# FPUD JOB NO. 3095 – SMRCUP Construction

## ADDENDUM D

June 26, 2019

This Addendum "D" includes clarifications and/or changes to the Contract Documents for the Fallbrook Public Utilities District, **Santa Margarita River Conjunctive Use Project Construction**

DRAWING NO. <b>500M-1</b>
SHEET NO. <b>180 OF 387</b>
CLIENT JOB NO. <b>2744</b>

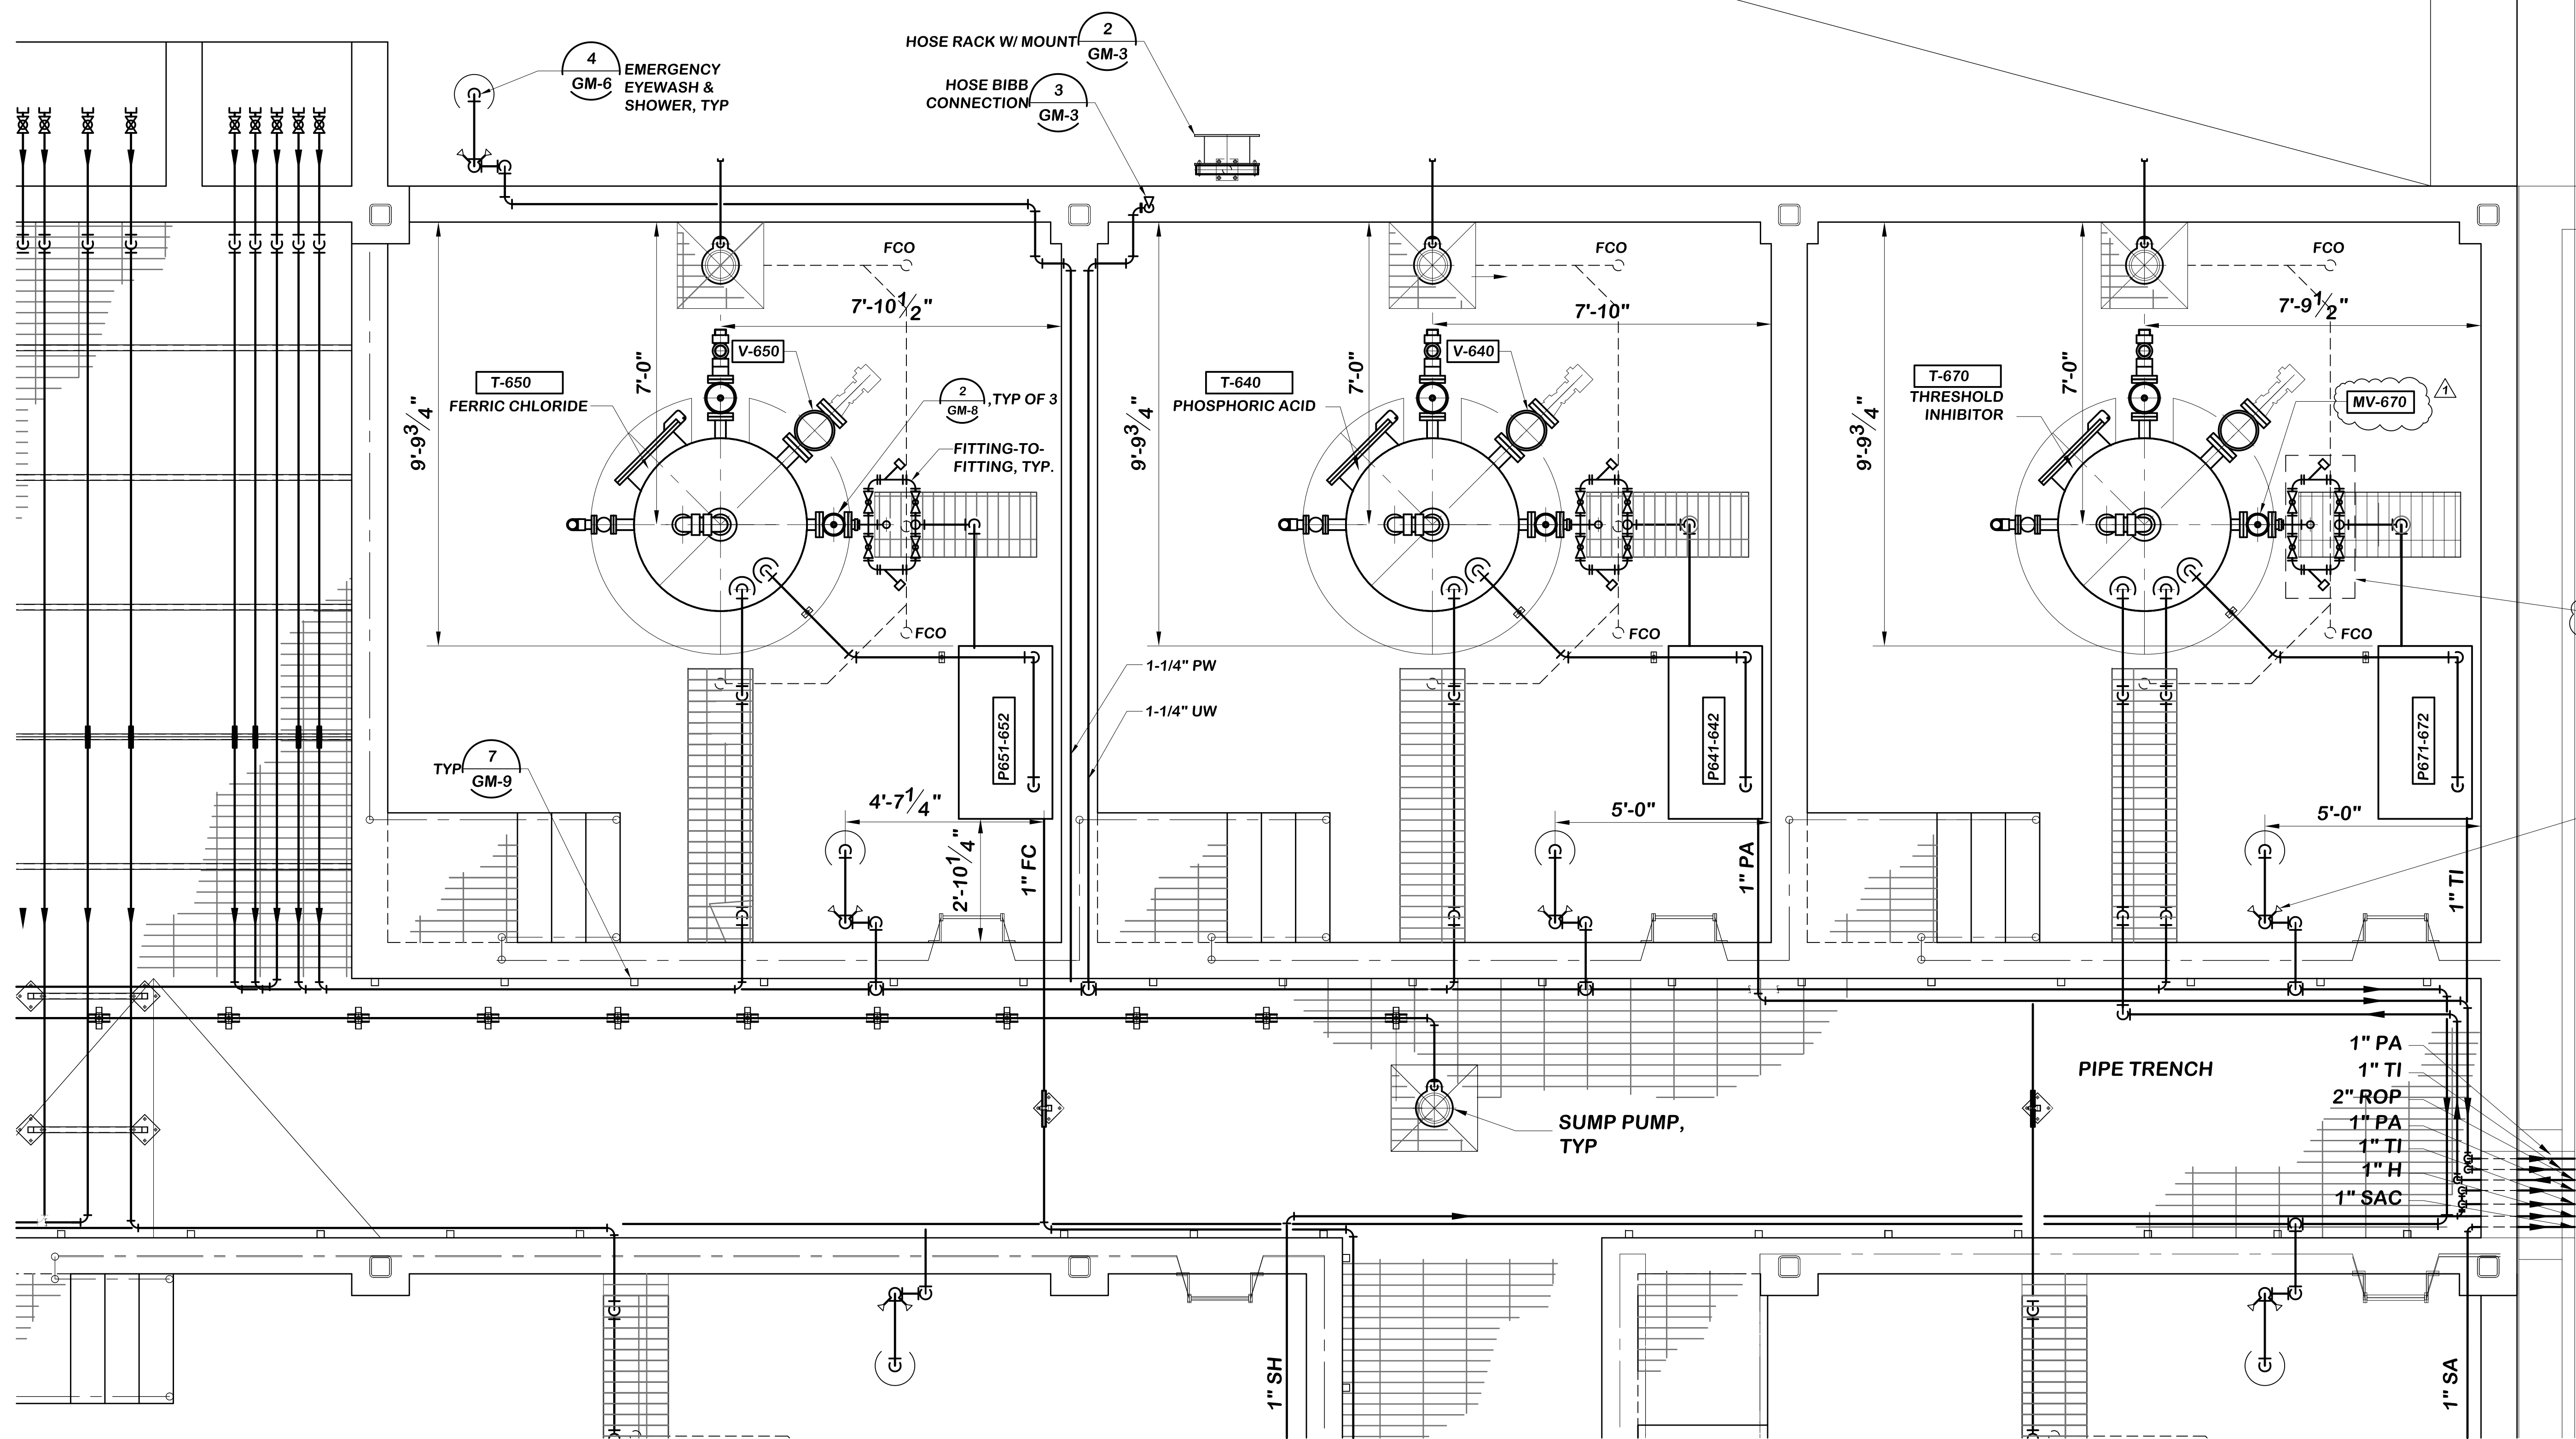
185	Valve SPEC Reference No., Size (in), Actuator Type, Actuator Designation, Pressure Class and Valve Type for Valve Tag No. V-501 indicated on Contract Drawing(s) 500M-1.	V-501 is the 24" buried BFFV located on the 24" suction line from tank T-500. Replace the valve tag on the 6" drain valve on T-500 on drawing 500M-1 from V-501 to V-500. See expanded valve schedule by addendum.
186	Valve SPEC Reference No., Size (in), Actuator Type, Actuator Designation, Pressure Class and Valve Type for Valve Tag No. V-550A indicated on Contract Drawing(s) 500I-2.	Added. See expanded valve schedule included by addendum.
187	Please confirm Valve Tag. No. V-670 should be MV-671 as it is has an electric actuator per the Partial Valve List included with Section 15100 Valves (General).	V-670 should be MV-670. See expanded valve schedule by addendum.
188	Valve SPEC Reference No.V348 for Valve Tag No. MV-600 as it is not included with Specification Section 15100 Valves (General). Please confirm 4-in size as this valve is indicated as 3-in on the Chemical Storage Tank Schedule on Contract Drawing 600M-9.	MV-600 does not exist. V-600 is the drain valve for T-600 an is valve type V345 not V348, 4". See revised Specification Section 15100 Valves and expanded valve schedule issued by addendum.
